SUBJECT: NEW VEHICLE DEMONSTRATION / DELIVERY HOLD
Safety Recall 25S95 - Supplement #1
Certain 2023-2024 Model Year Transit Internal Combustion Engine (ICE) Vehicles
Tire and Steering Shaft Bolt Replacement

New! REASON FOR THIS SUPPLEMENT

- **Parts List:** The replacement tire part number has been updated.
- **Technical Instructions:** The label inspection has been updated.

FIGURE 1

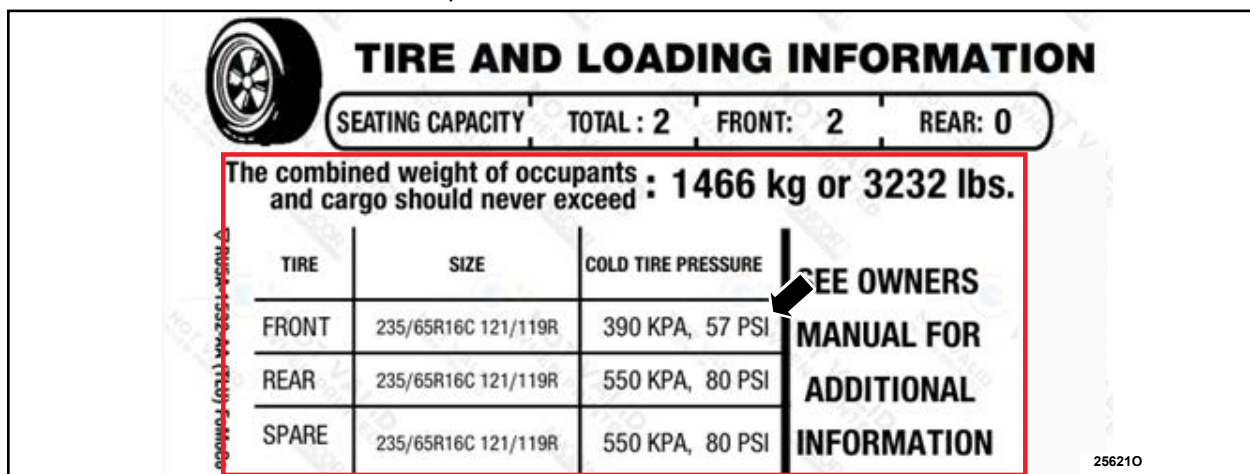
1. Inspect the TREAD Act label found on the driver-side door jamb. Does the TREAD label have the correct Vehicle Identification Number (VIN) and *front tire pressure of 57 PSI as shown in Figure 1?*

3. Confirm the VIN on the vehicle matches the VIN on the *new* labels being installed. See Figure 1.
